UNITED STATES
NUCLEAR REGULATORY COMMISSION

MEMORANDUM FOR: Docket File No. 40-8907

SUBJECT: AMENDMENT NO. 10 TO SOURCE MATERIAL LICENSE SUA-1475 FOR
 RECLAMATION AND CLOSURE OF THE UNITED NUCLEAR
 CORPORATION (UNC) CHURCH ROCK MILL NEAR GALLUP, NEW MEXICO

Figure 1

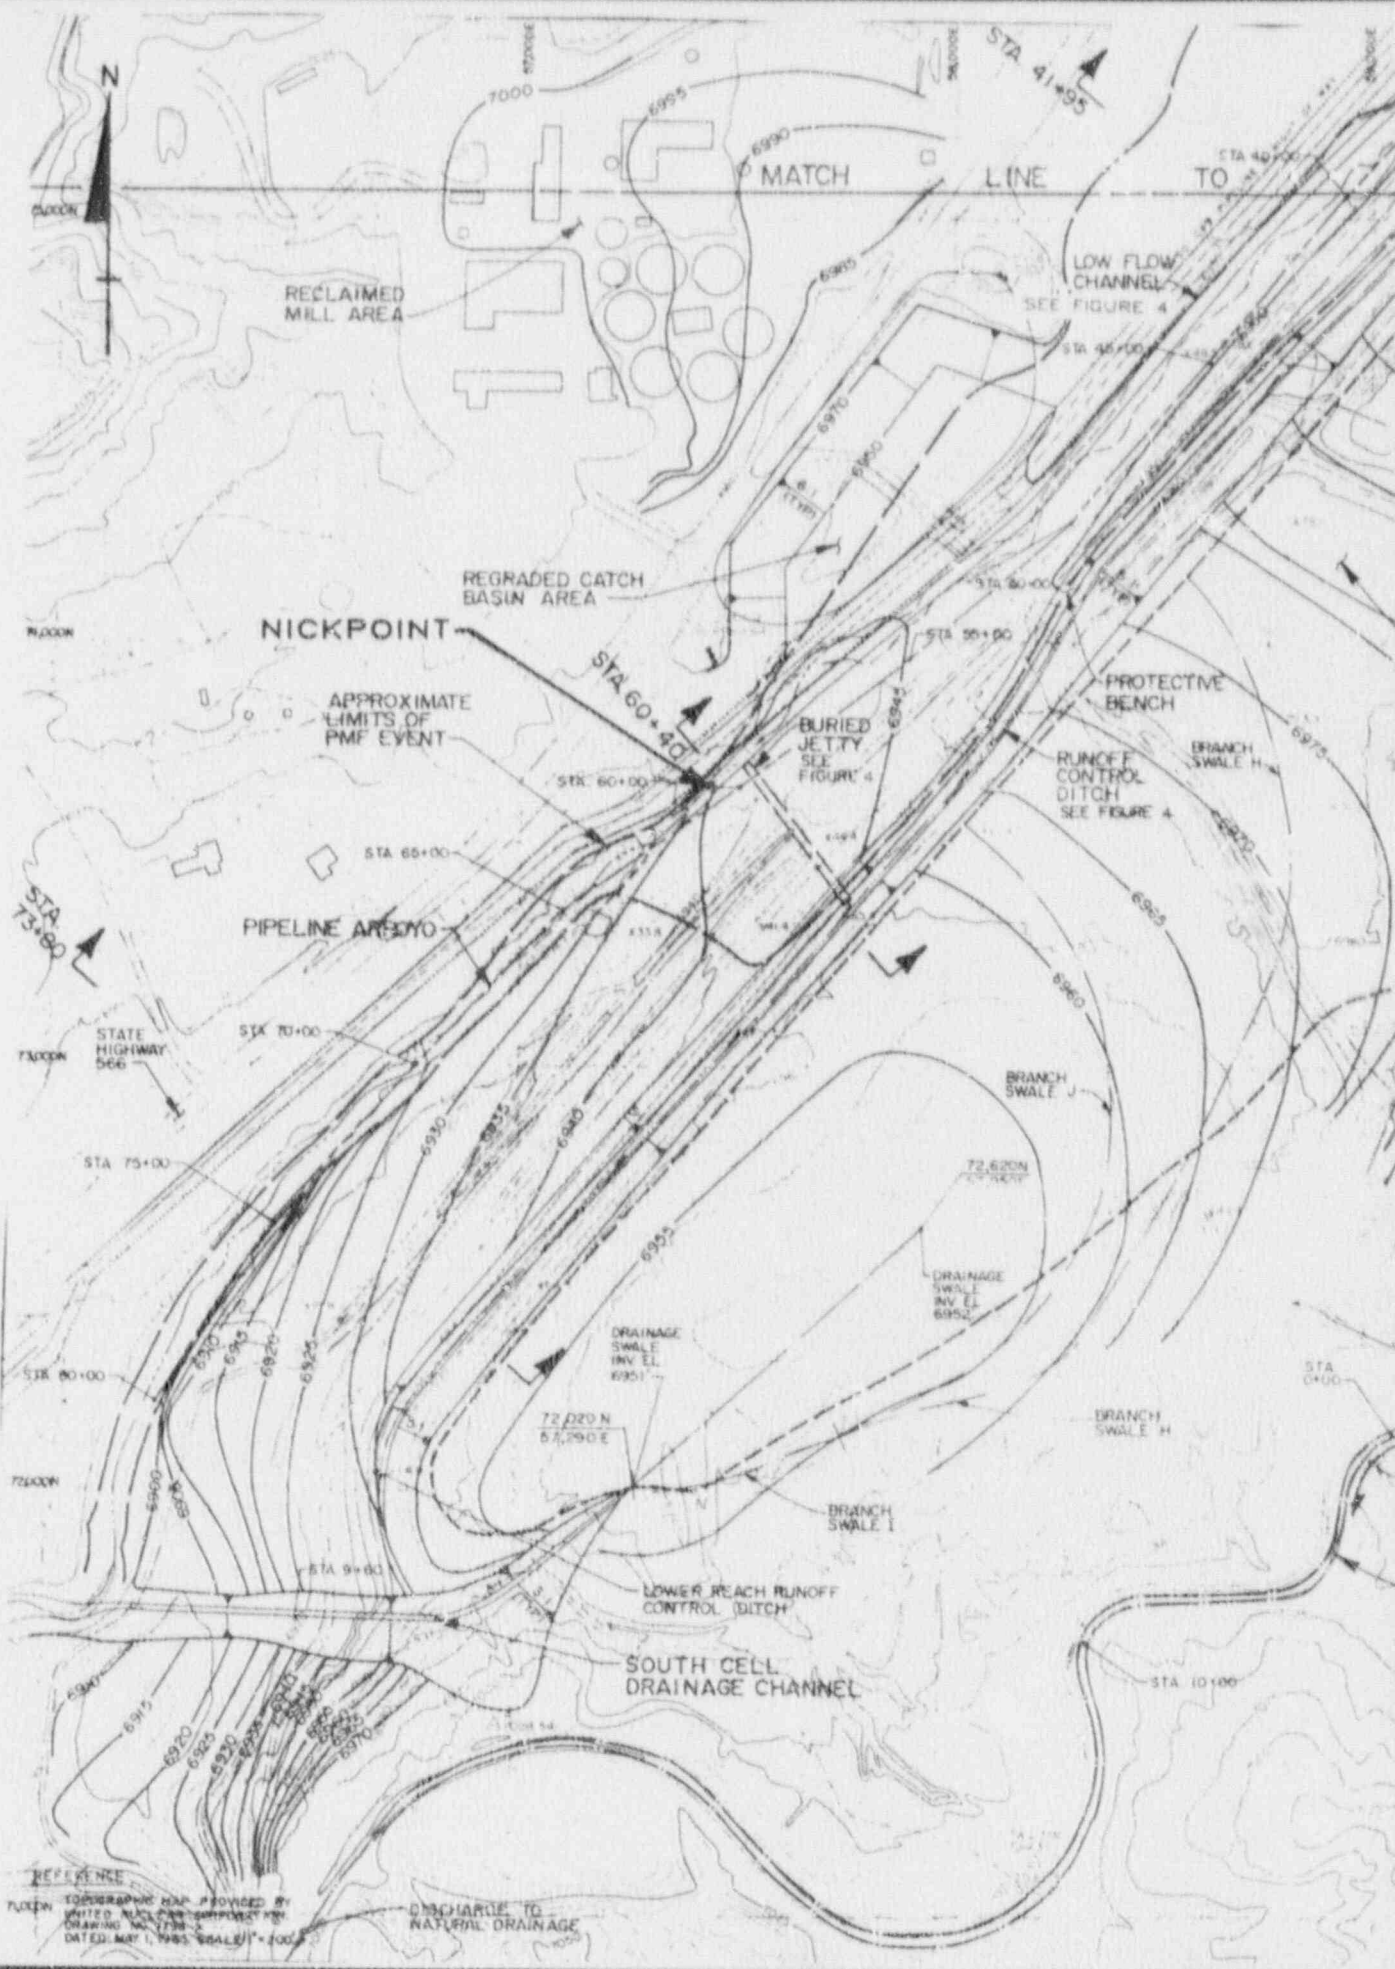
The tailings solution in the disposal area has been evaporated except for Borrow Pit No. 2, which is currently being used for storage of water extracted from tailings seepage and ground water (Figure 1 shows the location of the pit). A spray system is currently being used to evaporate the water from the borrow pit. Once the borrow pit has been drained, it will be reclaimed by backfilling with mill demolition debris, soil that is unsuitable for radon cover, and other soil as necessary. It is estimated that 500,000 cubic yards of material will be required to fill Borrow Pit No. 2 to final grade.

As shown on Figure 1, Pipeline Arroyo is an ephemeral channel that flows from northeast to southwest along the western edge of the disposal area. The arroyo has a massive bedrock outcrop adjacent to the tailings pile. This outcrop, which is designated as the "nickpoint" on Figure 2, stabilizes the arroyo by minimizing the potential for headcutting. As a result, the arroyo upgradient of the nickpoint is geomorphically stable, being characterized by a very flat

Figure 2

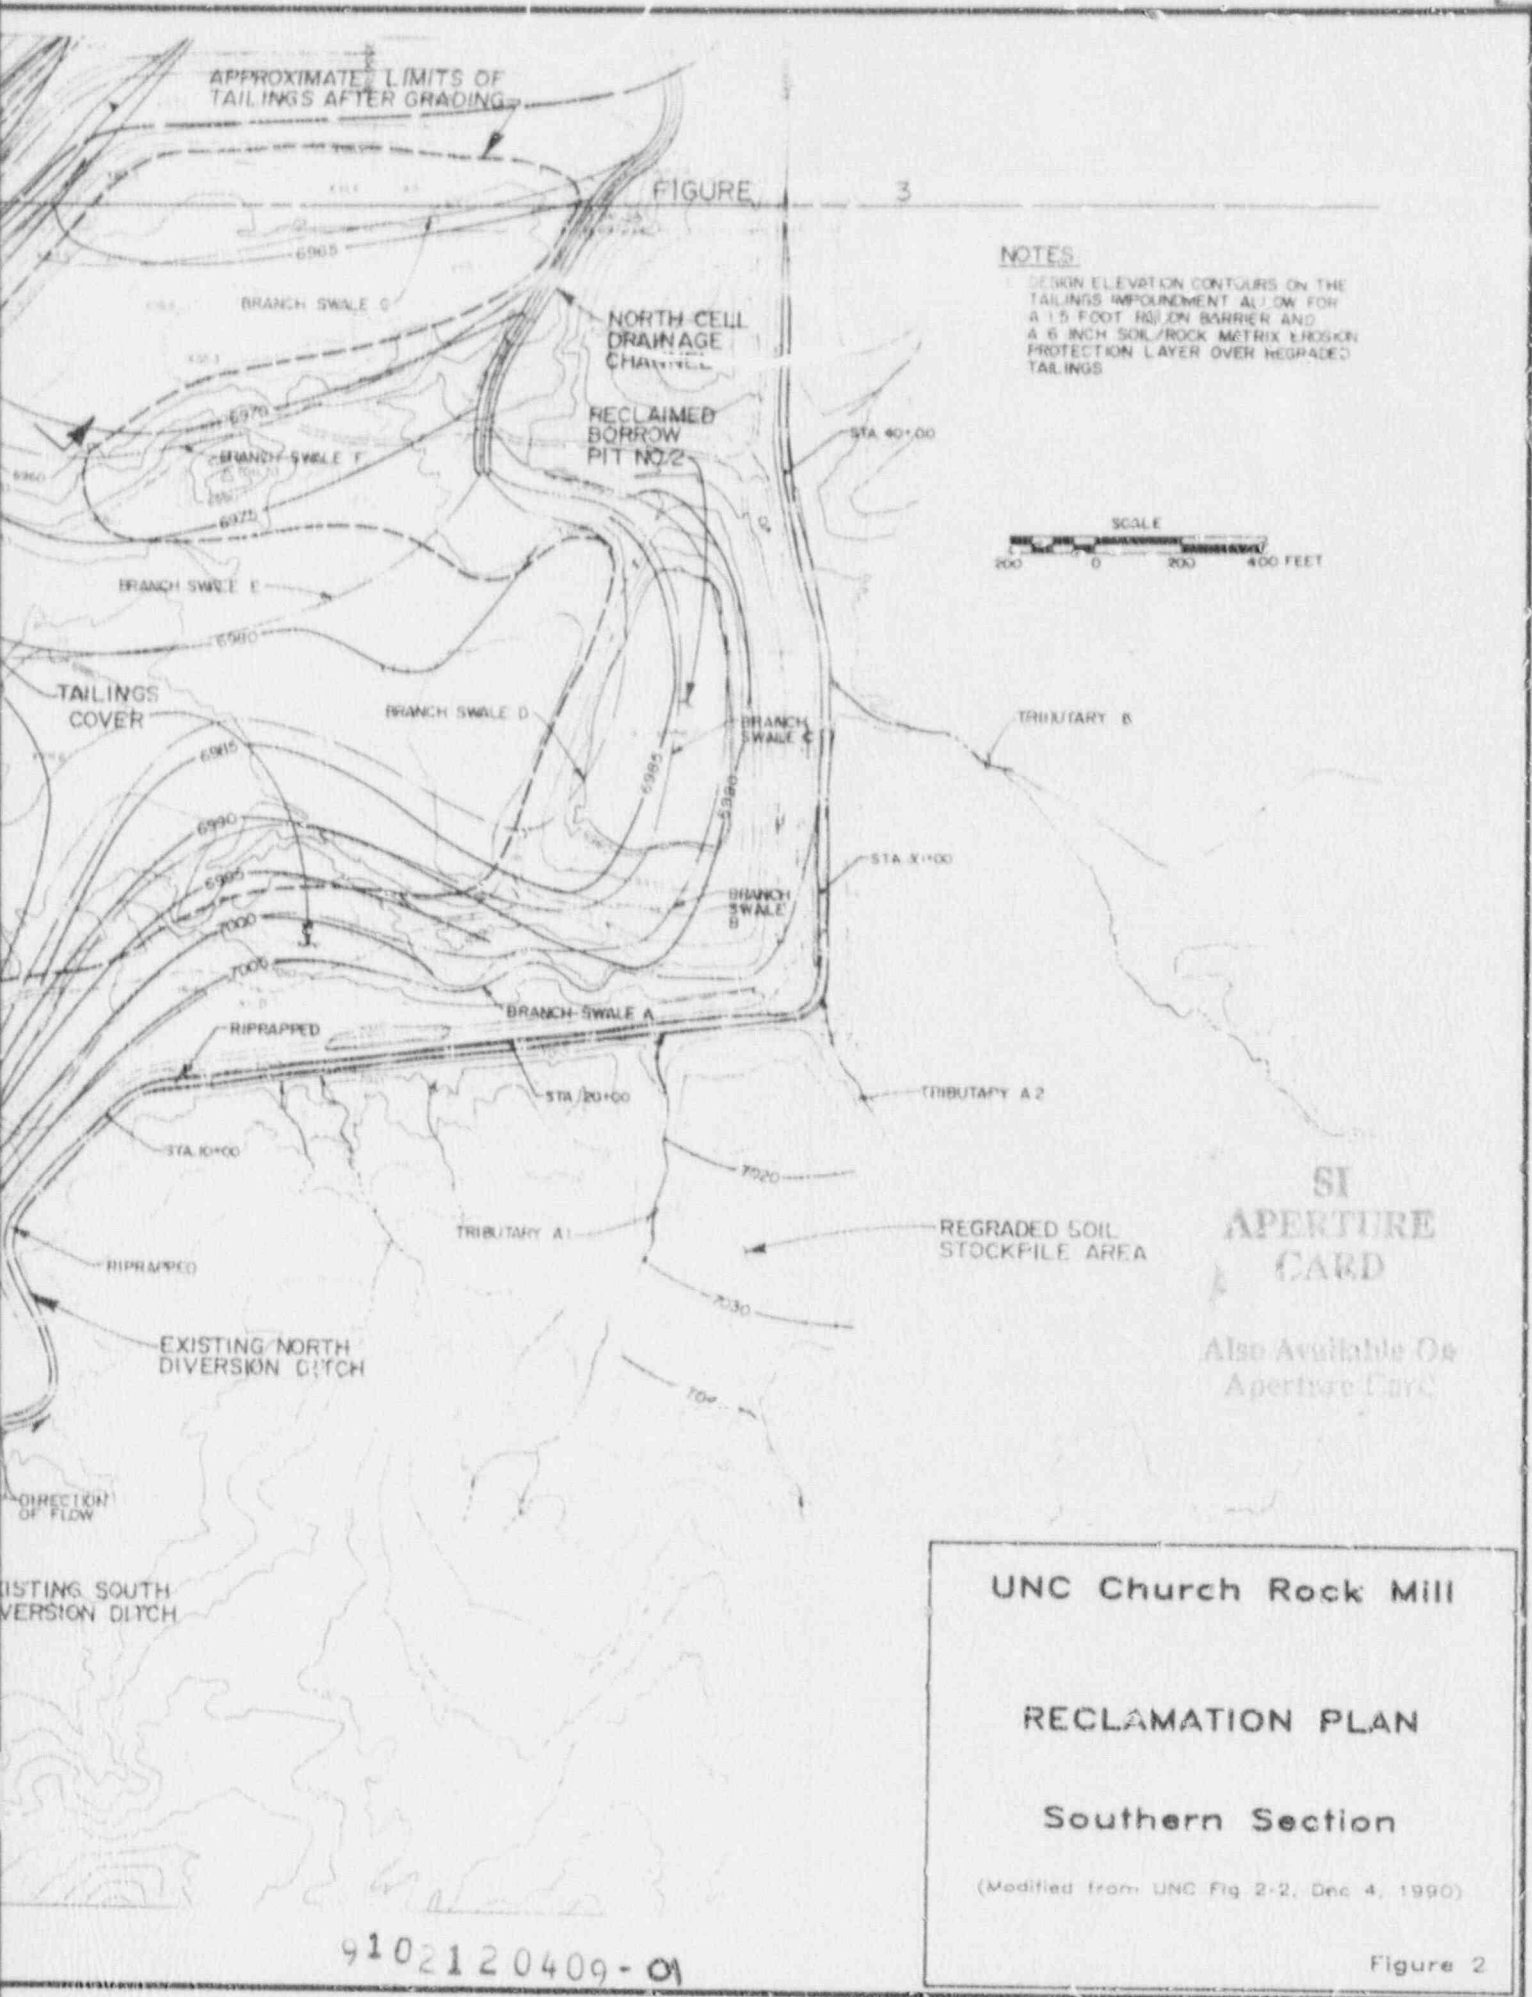
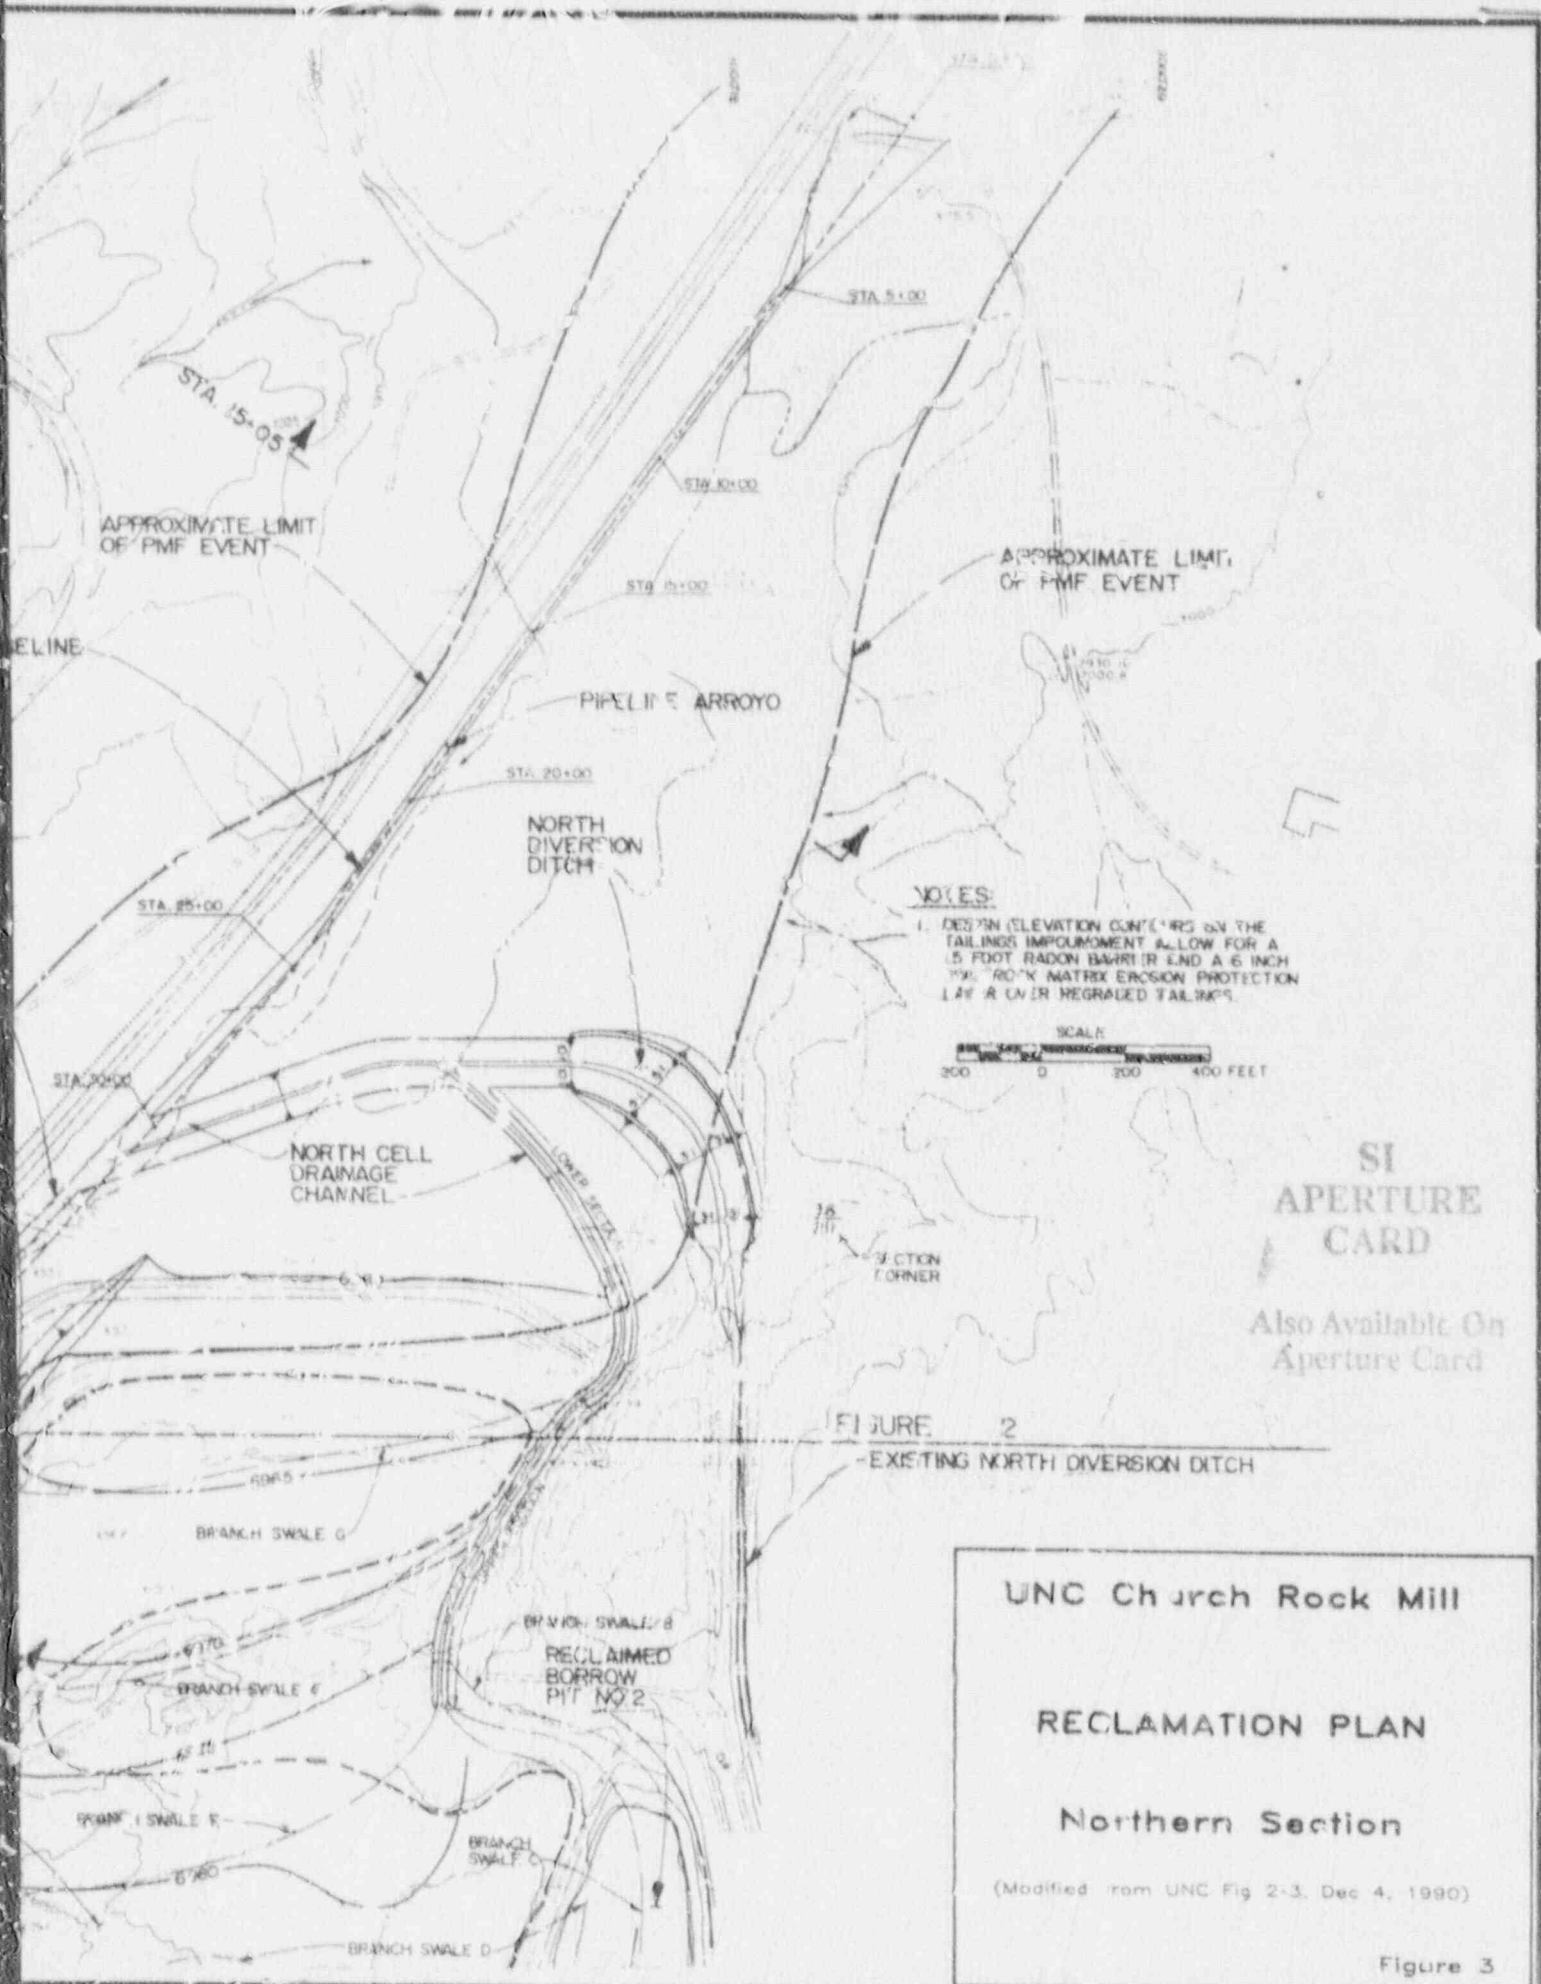
To demonstrate the stability of the reclaimed facility, a critical section was selected at Station 48 + 00 (See Figure 2) and analyzed under static and pseudodynamic loading. The section and the parameters used in the modeling are illustrated on Figure 7-11 of the June 1, 1987, submittal. The physical property values assumed for the homogeneous section are considered reasonable for the simplified section. The phreatic surface modeled represents a worst case. An acceleration coefficient of 0.05g was used to simulate earthquake

As discussed above, the Pipeline Arroyo nickpoint will be reinforced by construction of a buried jetty, as shown on Figure 2. The jetty will consist of a stone-filled trench that will extend across the valley from the nickpoint to the top of the protective bench along the toe of the tailings embankment. The purpose of the jetty is to provide vertical control of the Pipeline Arroyo channel bottom. This control will maintain the flat gradient of the arroyo upstream of the nickpoint and thus maintain the long-term geomorphic stability of Pipeline Arroyo. It will also ensure that flows will continue to pass over the nickpoint. In addition, the proposed low flow channel will contain smaller but more frequent flood events up to the 100-year flood and direct these flows over the nickpoint as far away from tailings as possible.

proposed to provide riprap at the two locations shown on Figure 2. In estimating the required riprap size, the licensee used the Maynard Method (Maynard, 1987). This analysis indicated that a D_{50} of 4.3 inches is required at one curve and 5.5 inches at the other. Based on this analysis, the licensee proposes to use a D_{50} of six inches at both locations. The thickness of the riprap layer will be nine inches and it will be underlain by a six-inch thick filter layer. Based on an independent review of the licensee's calculations, the riprap design of the North Diversion Ditch is acceptable.

As shown in Figure 2, slopes as steep as about 7.0 percent will converge onto the tailings surface from the east. To minimize the potential for erosion, the licensee proposes to limit flow distances and thus flow velocities by constructing branch swales perpendicular to the direction of flow. These branch swales, shown in Figures 2 and 3, will convey flows to either the North Cell Drainage Channel or the South Cell Drainage Channel.

The outslopes will be flattened to 20 percent (5H:1V). At the toe of the outslopes, a ditch identified as the Runoff Control Ditch (See Figures 2, 3, and 4) will prevent headcutting and provide stability to the outslopes. In addition, the ditch will minimize the runoff that will contribute to flows in Pipeline Arroyo. The riprap proposed for the outslopes is a 3-inch thick layer having a D_{50} of 1.5 inches. This D_{50} was estimated using an equation described in NUREG/CR-4651, Volume 2 (Abt and others, 1988). The design discharge used in this equation was calculated using the Rational Method (Chow, 1959) with a runoff coefficient of one and a flow concentration factor of three, which is conservative.
